Access Compliance Report

Public Rights-of-Way

(Curb Ramps)

Intersection ID: 8157	Main Street: N_TRYON_ST	Cross Street: ORR_RD	Location: SE
ADA ID: D5F5FE3CBBAC	Ramp Type: Perp	Initial Pass/Fail: Fail	Overall Compliance: No
		Severity Score: 10

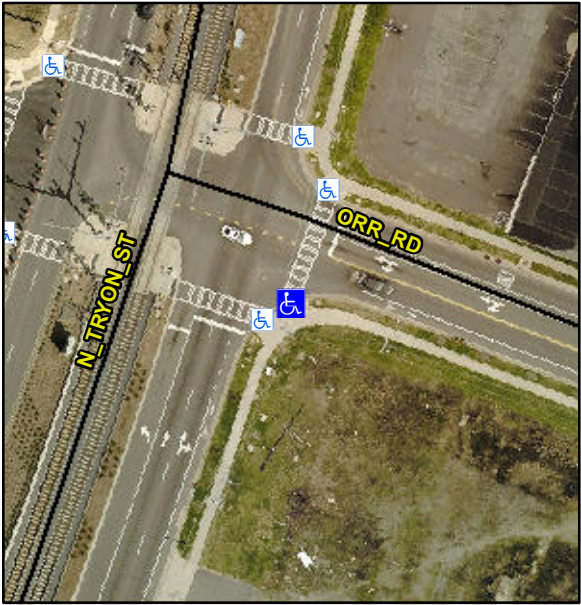
Codes/Mitigation Info/Possible Solution			Field Measurements/Component Compliance			
	Possible Solutions:		Compliance	Description	Data	Compliance
	Remove & Replace Entire Ramp.		Yes	Ramp Slope (%)	5.4	
			No	Ramp Width (in)	47.0	
			N/A	Flare Type LT	N/A	
			N/A	Flare Slope LT (%)	N/A	
			N/A	Flare Traversable LT?	N/A	
			N/A	Flare Traversable RT?	N/A	
			N/A	Landing Length (in)	N/A	
			N/A	Landing Width (in)	N/A	
			N/A	Landing Slope (%)	N/A	
Surveyor Notes: N/A PROW/ADA: R304.5.1, R304.5.3			N/A	Flare Type RT	N/A	
			N/A	Flare Slope RT (%)	N/A	
			N/A	DWS Provided?	N/A	
			N/A	DWS Contrast?	N/A	
			N/A	DWS Length (in)	N/A	
			N/A	DWS Full Width?	N/A	
			N/A	DWS Offset (in)	N/A	
			N/A	Gutter Ponding?	N/A	
			N/A	Gutter Lip Ht (in)	N/A	
			N/A	Painted X Walk1?	N/A	
Street 1 Name Stop Condition-Street 2 Street 2 Name Stop Condition-Street 1			Yes	Painted X Walk2?	N/A	
			To N	X Walk 2 Direction	N/A	
			N/A	X Walk 2 Width (in)	N/A

1.3	X Walk 2 Slope (%)	N/A	
			3.3	X Walk 2 X Slope (%)	N/A	
			Yes	Ramp inside XWalk2?	N/A	
			N/A	Clear Space?	N/A	
			N/A	Clear Space to XWalk (in)	N/A	
			N/A	Storm Grate/Utility Hazard?	N/A	
			N/A	Storm Grate/Utility Type	N/A	
Total Cost: \$ 1850.00			N/A	Surface Condition? (G/P)	Good
